Comments on Carp River Third Party Review

Ted Cooper, M.A.Sc., P.Eng.

April 19, 2009

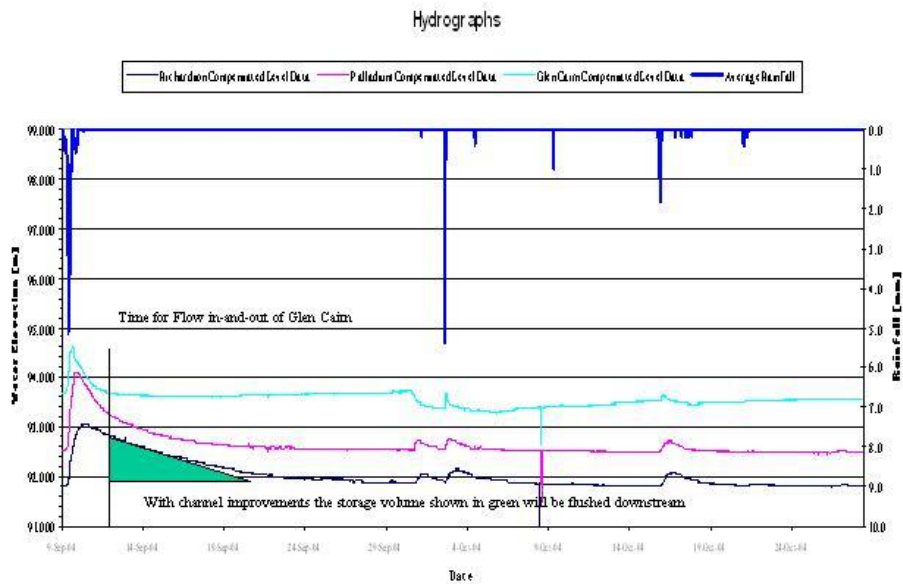
The issue of sufficient outlet (or lack thereof) formed part of my presentation to the TPR consultant and the PAC. The green triangle in the figure below corresponds to the riparian storage that would need to be displaced downstream, if the restoration plan results in a free flowing condition. If that riparian storage is shifted downstream, the impact on downstream flood levels will be larger than those documented in the TPR. When the increased runoff volume from Kanata West and Fernbank is factored in, the volume will be larger yet, and the flood level increase downstream will be that much more.
